Sunset Garden Senior Living Apartments

City of Puyallup
Development & Permitting Services
ISSUED PERMIT

Site Plan
A 236-Unit Apartment Project

Bradley Heights Apartments
Puyallup, Wa

SITE PLAN 236 UNITS

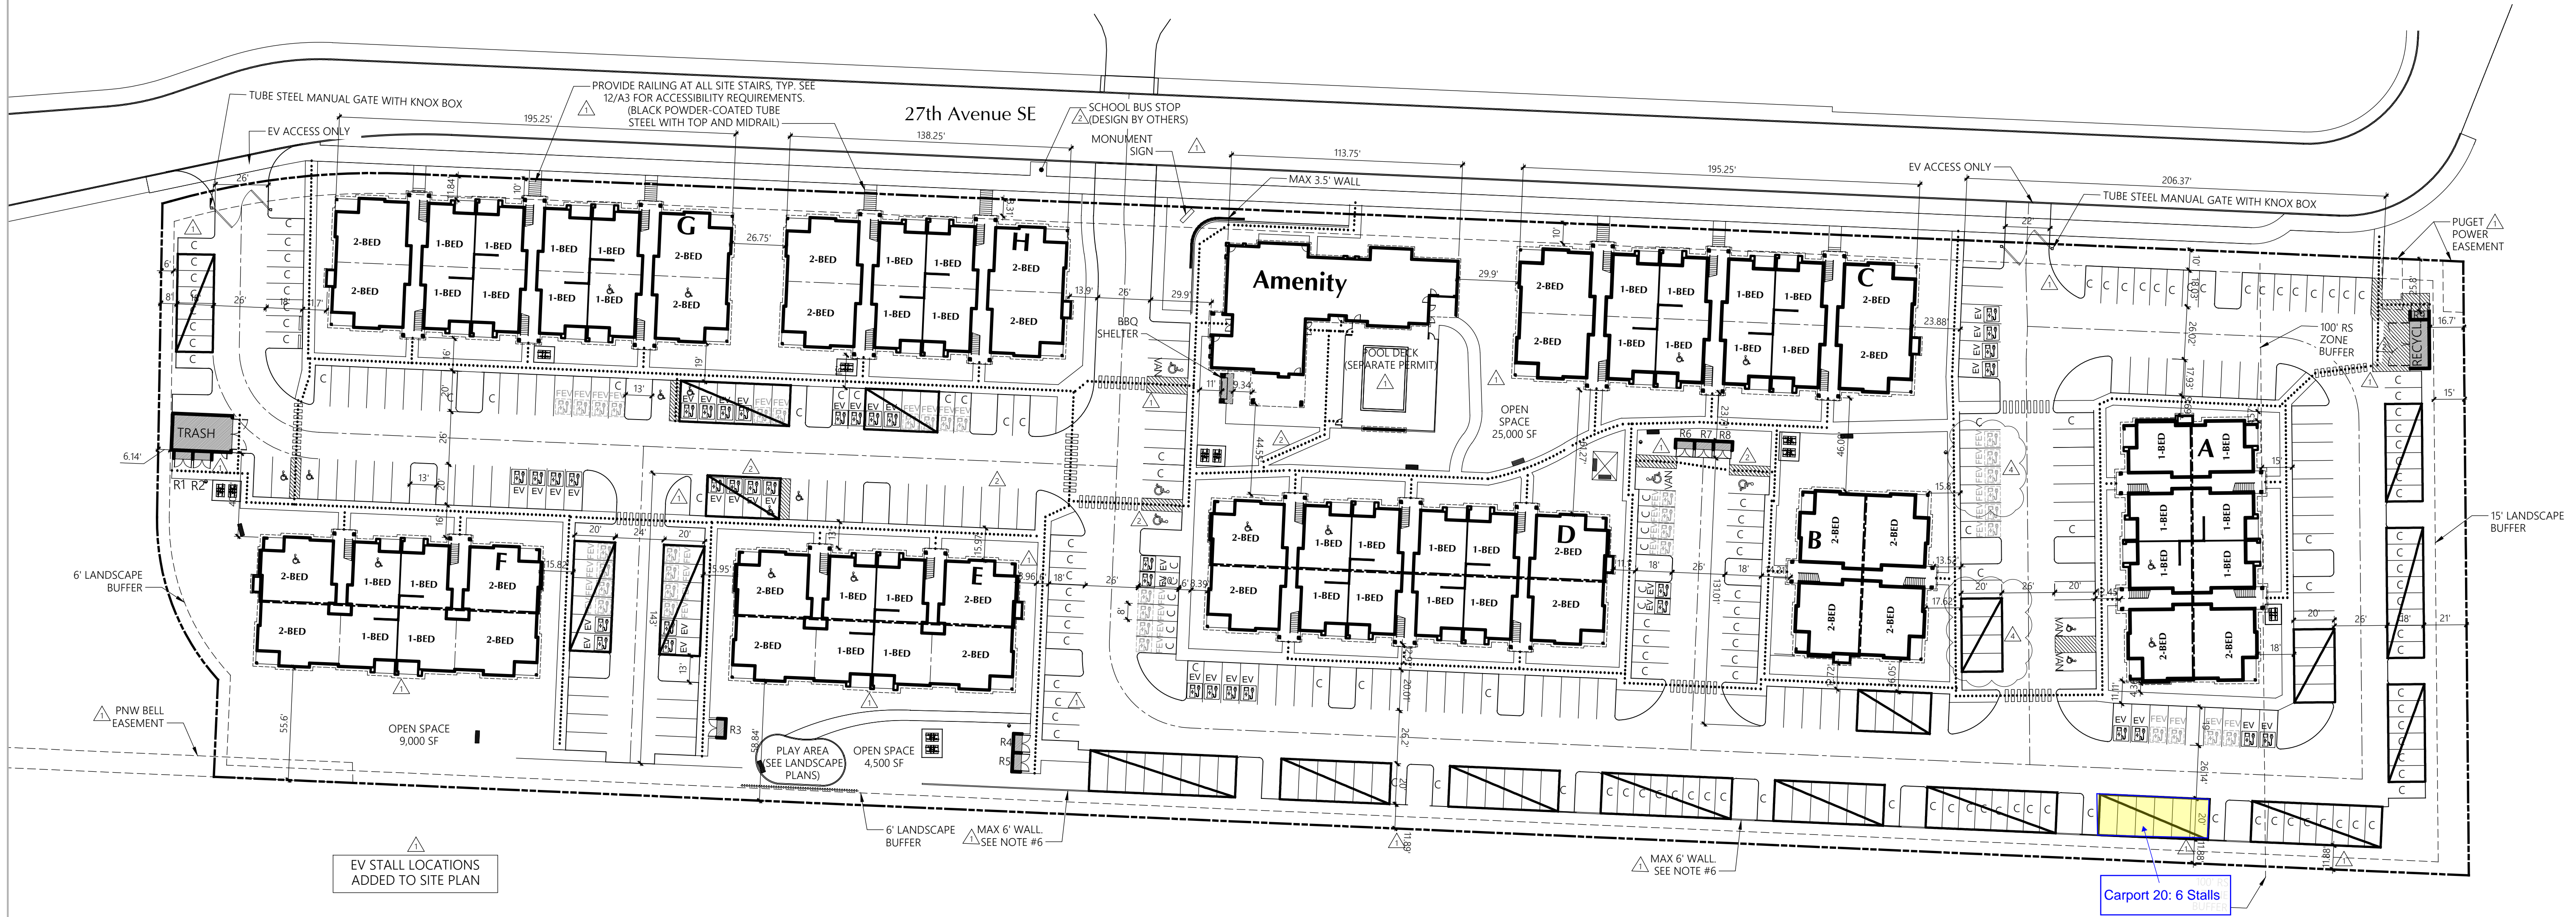
No proposed footings, posts, or supports shall be constructed on or above any existing public utility connections without first relocating the utility services or protecting it in place.

Roof downspout control is required. Steps shall be taken to prevent drainage onto adjacent lots. Refer to City standard details 02.05.01 & 02.05.05 for typical control methods. Stormwater runoff shall not concentrate to neighbors.

Staff: JHulseLow
 Date: 04/03/2026
 Front, rear, and side yard property lines shall be marked with string from surveying pins prior to footing inspection.
